State Significant Development Application 6076_ Mod 2 Section 96(1A) Modification Application

4 Murray Rose Avenue, Sydney Olympic Park

Commercial Development

Submitted to NSW Department of Planning & Environment
On Behalf of GPT RE Limited

Figure 3 – 4 Murray Rose Avenue Master Plan – Day 1
Source: Turner

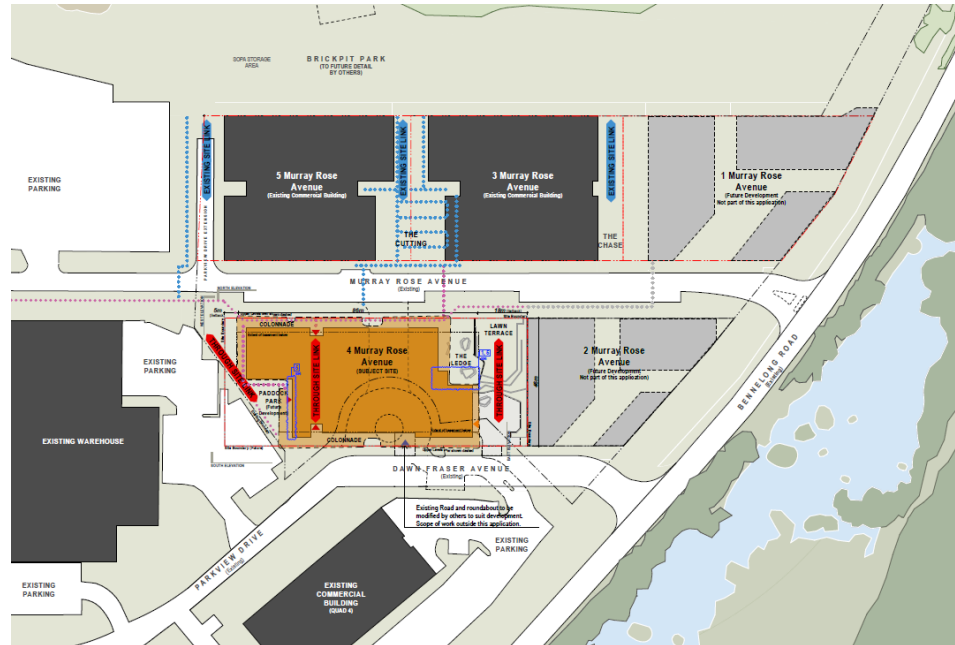
As the Precinct, will continue to develop, 4 Murray Rose has been modified to suit both the existing and future site conditions. These are known as 'Day 1', being the time that the development is completed but before surrounding works are completed, and 'Future', relating to when the entire precinct has been redeveloped in accordance with the MP 2030. These conditions are shown in **Figures 3 and 4**.
